Palo Verde Nuclear
Generating Station

**Subject: Palo Verde Nuclear Generating Station (PVNGS)
Units 1 and 3, Docket Nos. STN 50-528 and STN 50-530
Response to Request for Additional Information Regarding Steam
Generator Replacement and Power Uprate – Instrumentation and
Controls Section**

**Instrumentation and Controls Section,
Electrical and Instrumentation and Controls Branch
Questions and APS Responses**

**REQUEST FOR ADDITIONAL INFORMATION ON PVNGS UNITS 1 AND 3
STRETCH POWER UPRATE FROM 3876 MW_t TO 3990 MW_t**

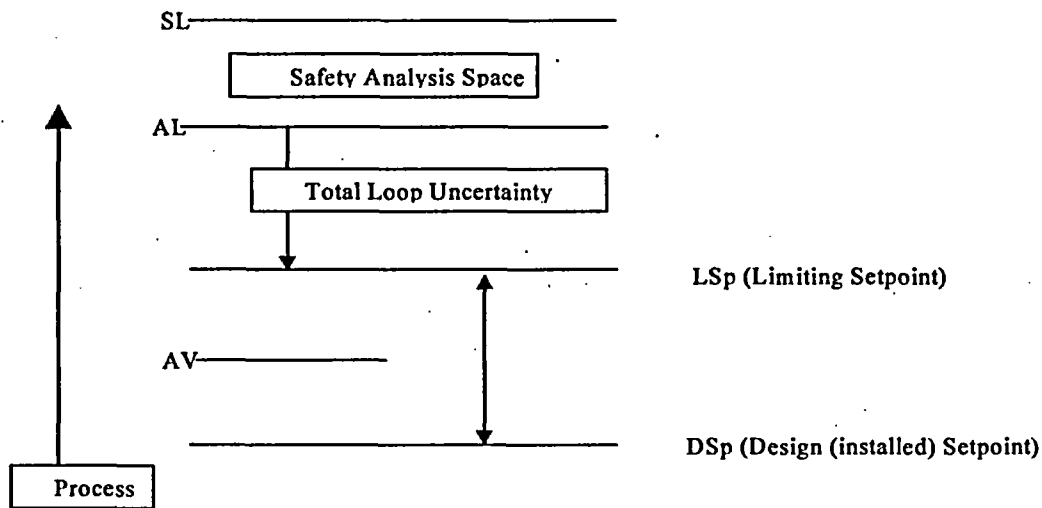
Discuss the setpoint methodology used at PVNGS to establish AVs associated with LSSS setpoints.

PVNGS is committed to RG 1.105 revision 1 with exceptions specified in the UFSAR, section 1.8, as a basis for meeting the requirements of 10CFR50, Appendix A, General Design Criteria 13 and 20. Our current practice provides more details than required by RG 1.105 revision 1. The setpoint project at PVNGS, by choice, used the principles of ANSI/ISA S67.04-1988, "Setpoints for Nuclear Safety-Related Instrumentation" and RP67.04 (then draft 9) in developing the design guide ("Design Guide for Instrument Uncertainty and Setpoint Determination" DSG-IC-0205) which was the method by which the calculations of the project were accomplished.

Of the three methods for determining the AV as described in Instrument Society of America (ISA) recommended practice ISA-RP67.04-1994, Part II, "Methodologies for Determination of Setpoints for Nuclear Safety-Related Instrumentation"; the PVNGS methodology is more similar to method 2 or 3, than method 1. This is because the total loop uncertainty (TLU), which is used to calculate a limiting (least conservative) setpoint (LSp), is determined by the Square Root Sum of the Squares combination of the COT (potential instrument uncertainties expected during Channel Operability Testing) and nCOT (composite of all other potential instrument uncertainties not addressed in the COT). Method 1 on the other hand, determines the TLU by adding the COT + nCOT.

The concern the Staff has (had) with respect to the ISA 67.04 Part II Method 3 is in the determination of the Allowable Value (AV). These concerns should not apply to the PVNGS methodology.

When PVNGS first developed the uncertainty and setpoint methodology and calculations, the Allowable Values listed in the Technical Specifications already existed based on the calculations provided by Combustion Engineering (CE). A goal of the PVNGS setpoint program was to clarify the methodology and resulting calculations, and if possible, avoid making changes to the existing Technical Specifications values or any field installed design setpoints (DSp) if the resulting calculations validated the existing values as conservative. The current PVNGS

calculations validate the existing Allowable Values. The Staff concern is that the methodology provides assurance that the AV is still satisfied by providing a large enough allowance for those uncertainties not measured during the operability test. The reason that the Staff finds either Method 1 or Method 2 acceptable is that the allowance between the Analytical Limit (AL) and the AV is defined by the magnitude of the nCOT. The PVNGS methodology and resulting calculation can demonstrate that the allowance between the AL and the AV exceeds the magnitude of the nCOT and that of the entire Total Loop Uncertainty (TLU) as well, for the LSSS value being changed under this LAR. The AL and thus, the associated Safety Limit (SL), will be preserved if a trip setpoint is found to be within the AV during surveillance testing. Therefore, operability is ensured in the Technical Specifications. The following figure shows these relative relationships (based on a rising process and high limit):

Total Loop Uncertainty = appropriate statistical combination of random and bias COT and nCOT terms.
